Airworthiness Directives; Robinson Helicopter Company Helicopters

ACTION: Notice of proposed rulemaking

Robinson Helicopter Company: Docket No. FAA-2025-0011; Project Identifier AD-2024-00618-R.

Figure 1 to Paragraph (g)(1)(i)—Flex Plate Inspection

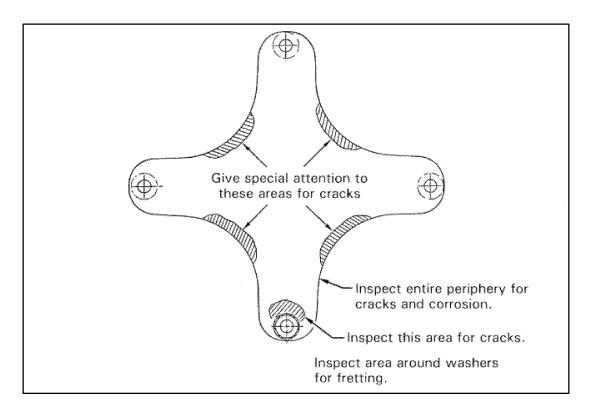
- (1) Within 100 hours time-in-service (TIS) after the effective date of this AD, accomplish the actions required by paragraphs (g)(1)(i) through (iii) of this AD.
- (i) Visually inspect forward flex plate assembly part number (P/N) C947–1 (flex plate) for any loose fasteners, cracks, fretting, corrosion, wear, and to ensure that the washers are bonded to both sides of each flex plate arm, in the areas depicted in Figure 1 to paragraph (g)(1)(i) of this AD. If there is any loose fastener (can be moved by hand), crack, fretting, corrosion, or wear that consists of the washers not securely bonded to both sides of each flex plate arm, before further flight, remove the flex plate from service and replace it with an airworthy flex plate.

Note 1 to paragraph (g)(1)(i): The flex plate may be installed in order to accomplish the visual inspection.
